SITE PLAN REVIEW AND APPEARANCE BOARD

CITY OF DELRAY BEACH

---STAFF REPORT---

ITEM: Seaglass Cottages (104 Andrews Avenue) – Class V Site Plan associated with demolition of an existing single family residence and construction of a three-story 5-unit fee simple townhome development with a swimming pool and 2-car garage serving each unit.

Site Plan

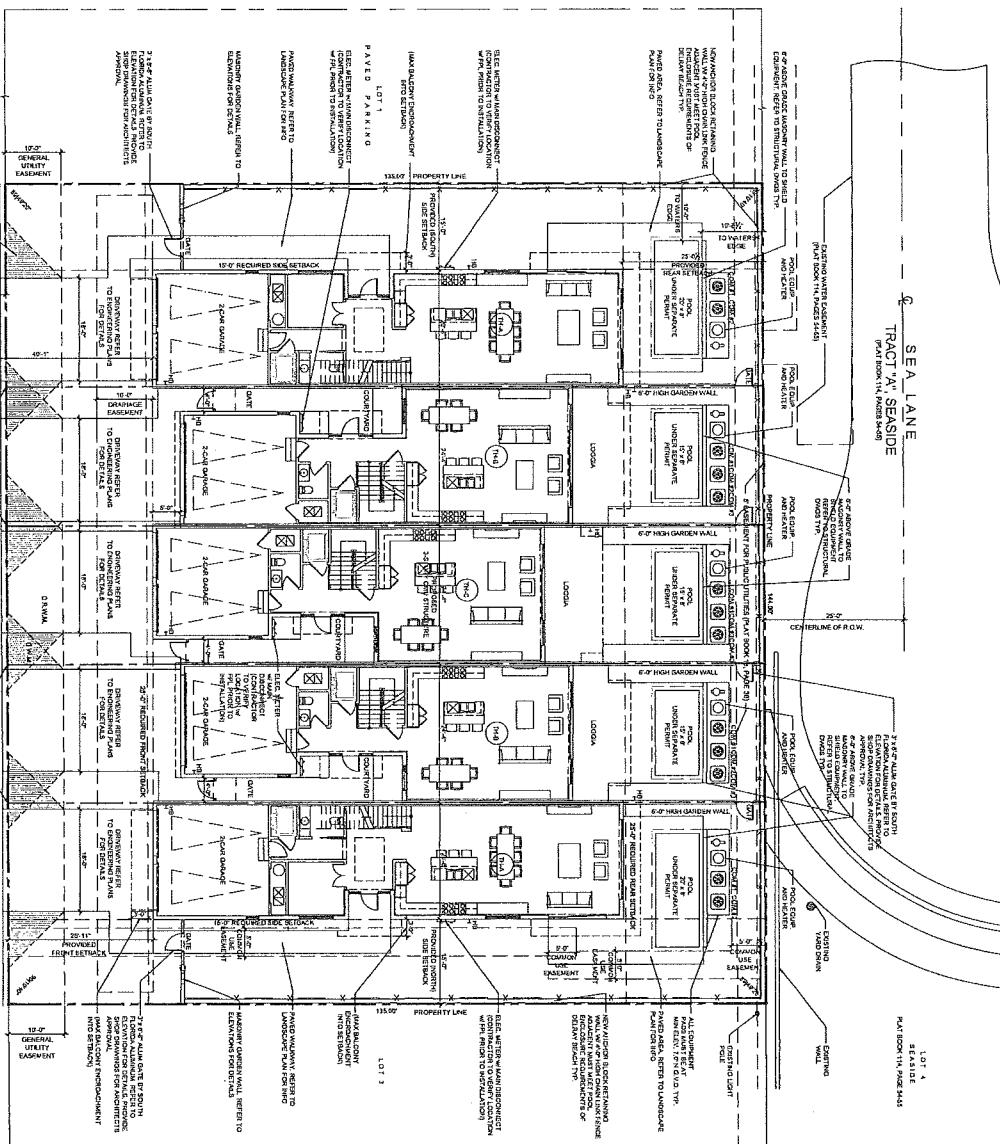
6. Include a unit size data chart on the site plan (Sheet SP-1) to demonstrate compliance with minimum square footage requirements for each unit.
7. Provide the City with delivery confirmation receipts to verify that the "Notification of Utility Providers Form" has been distributed to FPL, Comcast and AT&T for review and comments. Returned forms with no adverse comments, must be obtained prior to site plan certification.

6. Include a unit size data chart on the site plan (Sheet SP-1) to demonstrate compliance with minimum square footage requirements for each unit.
7. Provide the City with delivery confirmation receipts to verify that the "Notification of Utility Providers Form" has been distributed to FPL, Comcast and AT&T for review and comments. Returned forms with no adverse comments, must be obtained prior to site plan certification.
